Addendum No. 2

To: Interested Parties
From: John E. Van Riper, Project Engineer
Division of Engineering
Date: Friday, October 12, 2018
Project: Washington County Employee Parking Facility

Washington County Employee Parking Facility

FRENCH DRAIN DETAILS
WASHINGTON COUNTY EMPLOYEE
PARKING FACILITY

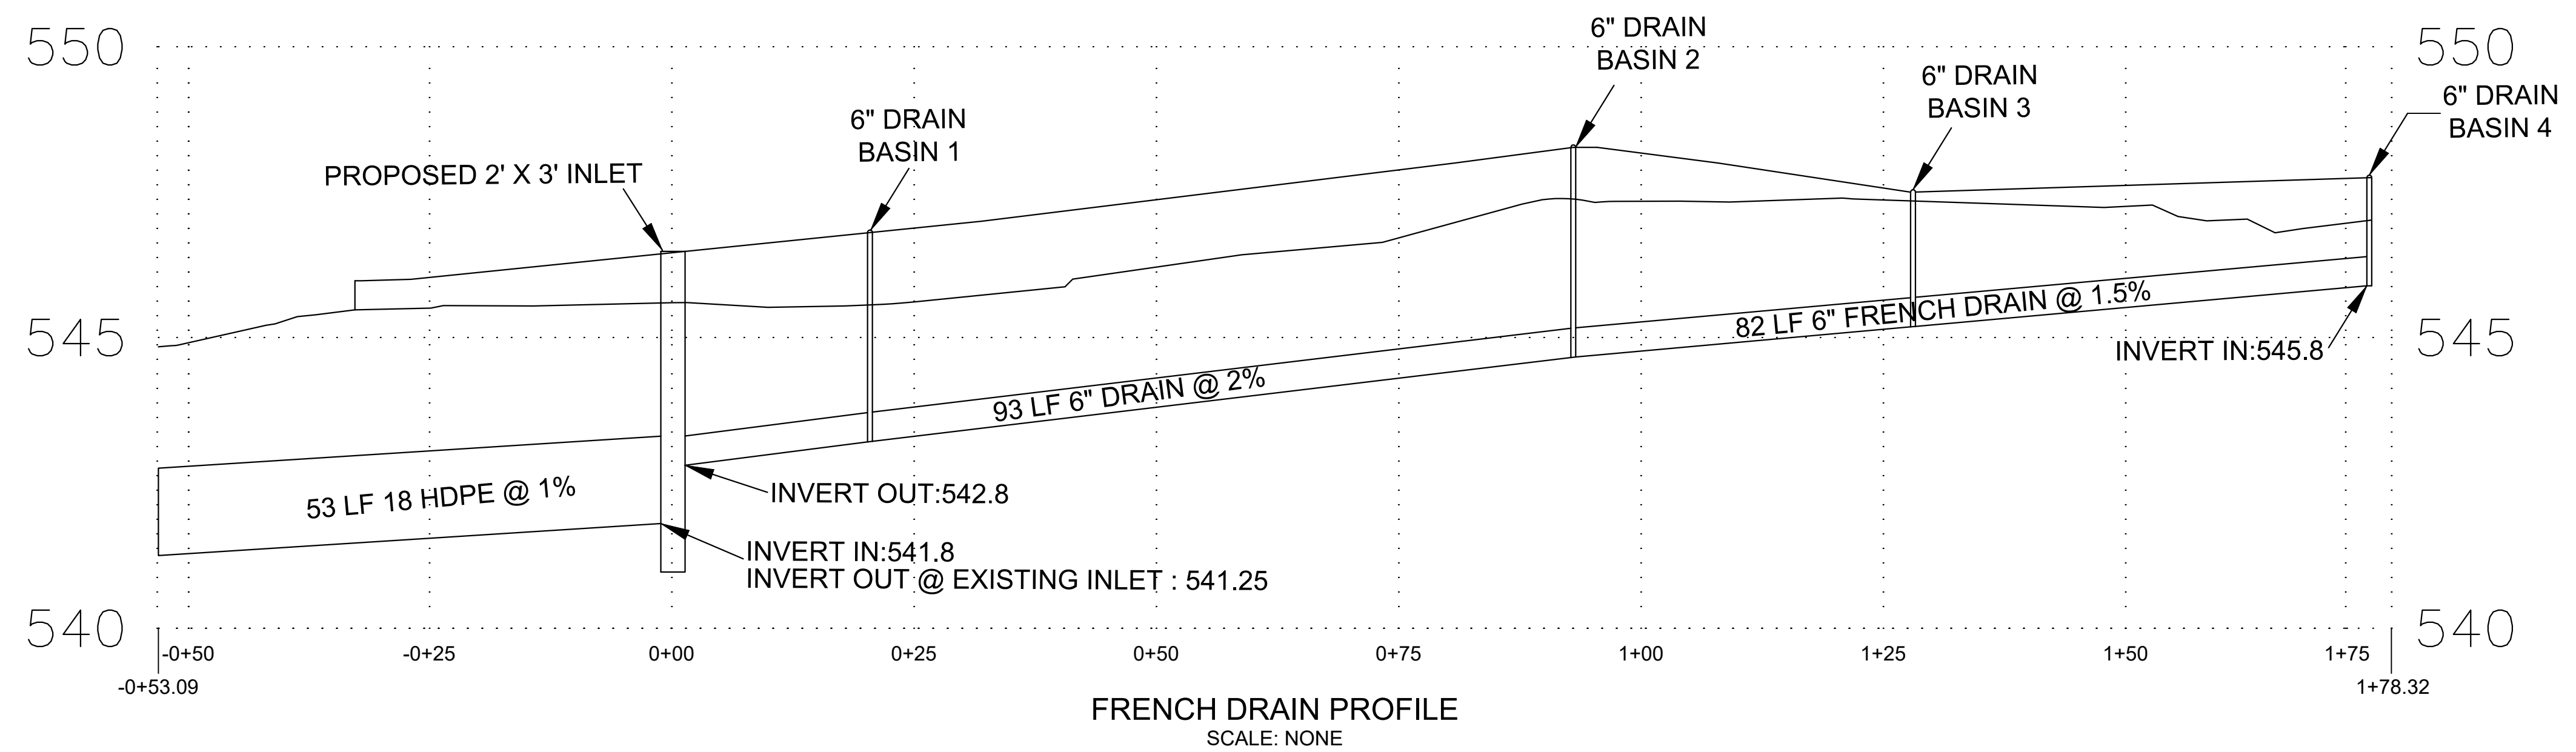
Item 2.16 **Q16 from Larry Weigle of Excavating Associates, Inc.: Bid item calls for 85 L.Ft. 6" perf pipe, bid item 306 calls for 100 L.Ft. 6" pipe. Profile on plan sheet 11 shows all of the 6" pipe to be perforated pipe (+/- 175 L.Ft.) Where do we install 6" non-perforated pipe?** Non Perforated pipe is to be installed From STA 0+00 to STA 0+94 shown on revised drawing sheet 11 (Attachment "C"). Perforated pipe is to be installed

from STA 0+94 to STA 1+76 as shown on the revised drawing sheet 11 (Attachment “C”)
